**STAFF RECOMMENDATION**  
**714 Shelby Avenue**  
**May 17, 2017**

**Application:** New construction-infill  
**District:** Edgefield Historic Preservation Zoning Overlay  
**Council District:** 06  
**Map and Parcel Number:** 09304003300  
**Applicant:** Jason Quiram  
**Project Lead:** Paul Hoffman, paul.hoffman@nashville.gov

**Description of Project:** Construction of a new two-family building on a vacant lot.

○ FRONT ELEVATION SCALE 1/8" = 1'

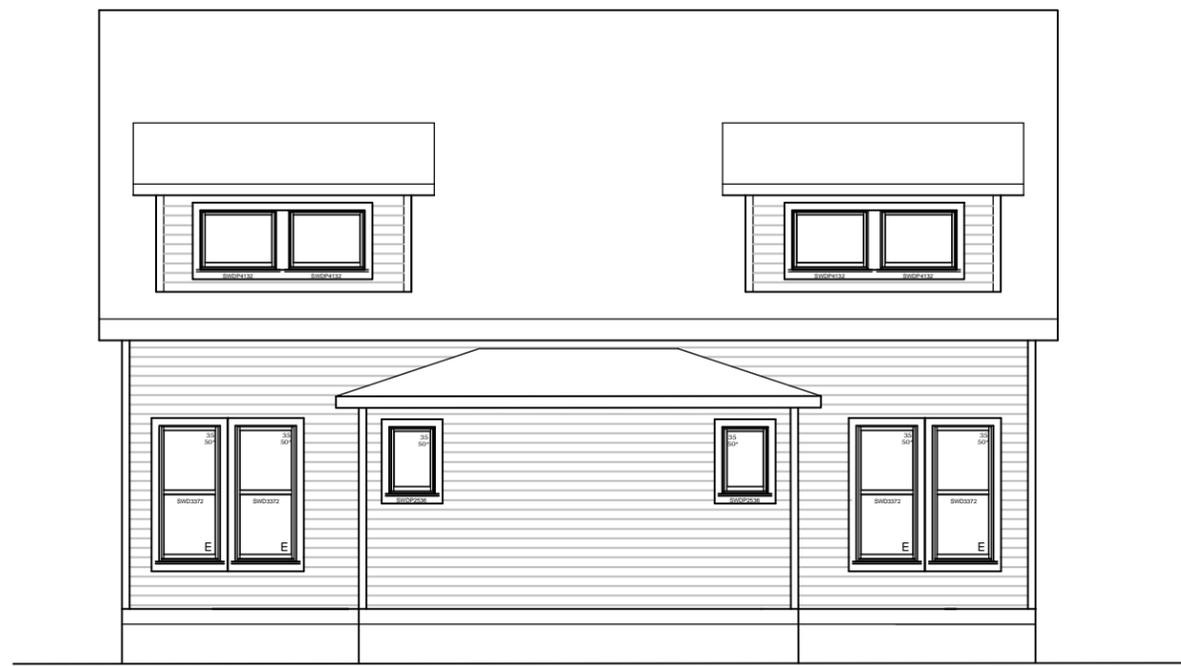
Building and Roof Shape: The building is a side-gabled form with a projecting central bay with a porch on each side of the bay. There are examples of a projecting bay on a building's front façade seen in the district, usually in an offset form to one side of a porch. These examples are normally one story, terminating in the middle of the roof, instead of carrying up nearly to the ridge of the house (Figures 2-3).

The best solutions could be a combination of different options such as moving the bay to be off-center, removing the bay, changing the height of the bay, and making the porches deeper. Because each solution entails multiple alterations and because the proposal is minimally altered from the disapproved version, staff recommends disapproval.

Staff finds that the application does not meet section III.B.2.c and III.B.2.d.

○ REAR ELEVATION SCALE 1/8" = 1'

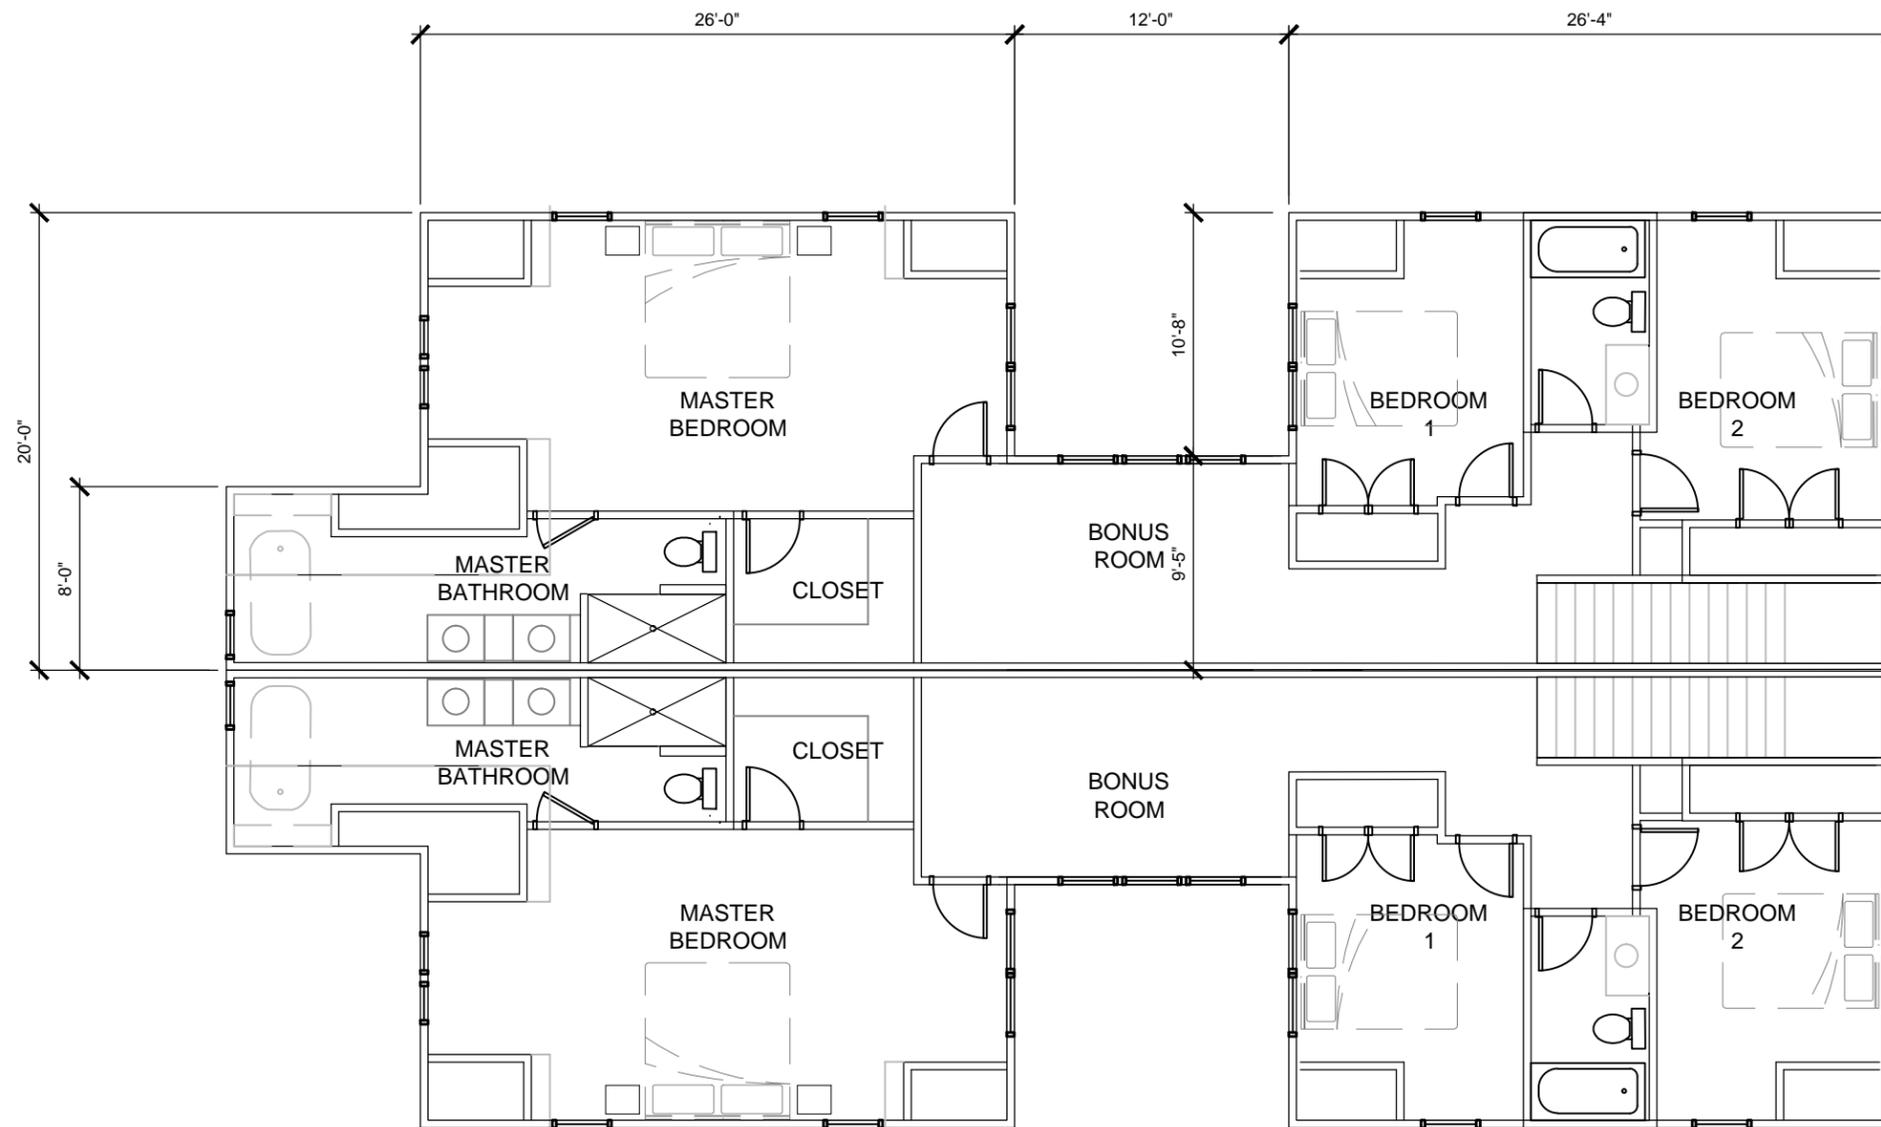
Between the side-gabled sections the house narrows and includes a wall dormer on each side. Wall dormers are not typically appropriate, but as this section of the house will be hidden from view behind the gabled part in front of it, Staff finds it appropriate in this case.

**Proportion and Rhythm of Openings:** The remaining windows on the house are generally twice as tall as they are wide, thereby meeting the historic proportion of window openings. There are no large expanses of wall space without a window or door opening. Staff recommends that all double and triple window sets have a four to six inch (4"-6") mullion in between them.

With four to six inch (4"-6") mullions on all paired and triple window openings, staff finds the project's proportion and rhythm of openings to meet Section III.B.2.f. of the design guidelines.
